Georgia Institute of Technology

NEELY NUCLEAR RESEARCH
CENTER

June 11, 1984

Re: Docket No. 50-160

*Please Note:
This is the
New Organization
Chart.*

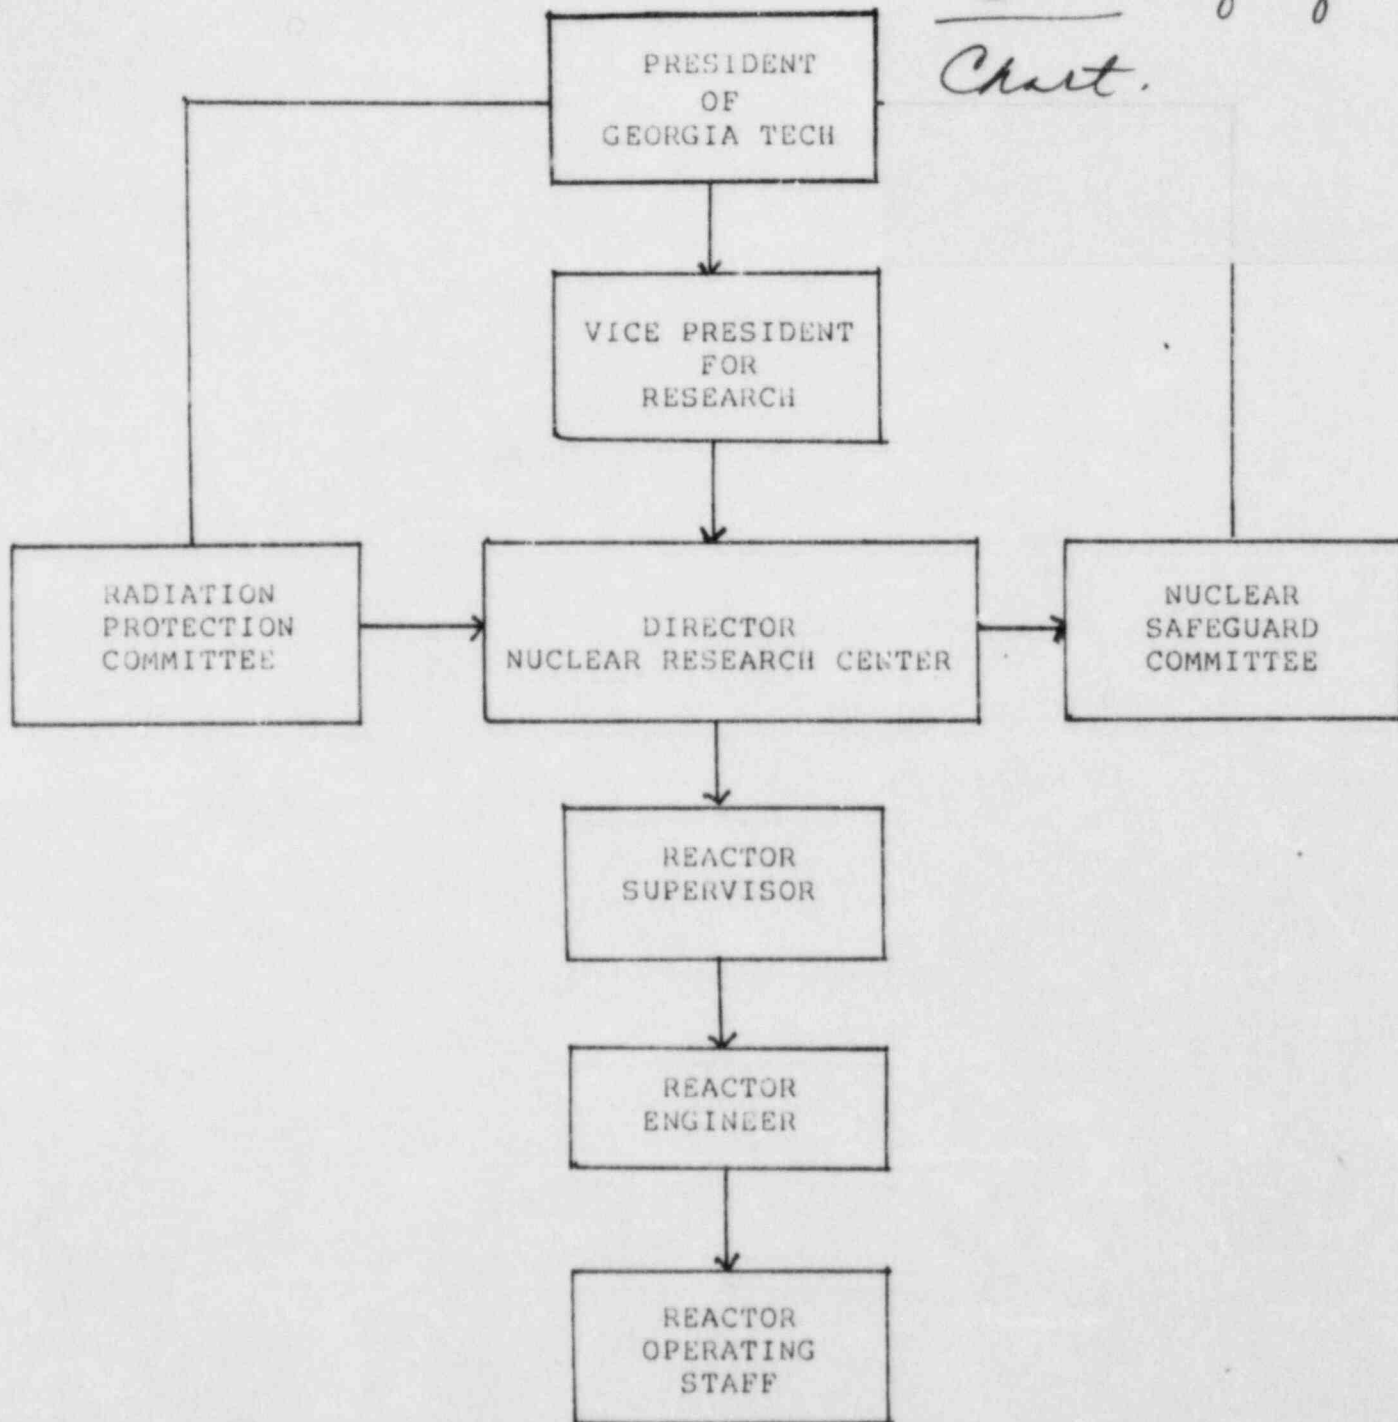
In addition to personnel changes, the organization for the management of the GTRR will change, effective July 1, 1984 from what appears on page 39 of the Technical Specifications of the GTRR (enclosed as old organization chart) to what appears in the enclosed "new" organization chart. The management of Georgia Tech prefers that the Director of the Nuclear Research Center reports to the President of Georgia Tech through the Vice President for Research instead of through the Dean of Engineering. Should this change require an amendment to our Technical Specifications then please consider this letter as a request to amend our Technical Specifications. Thank you.
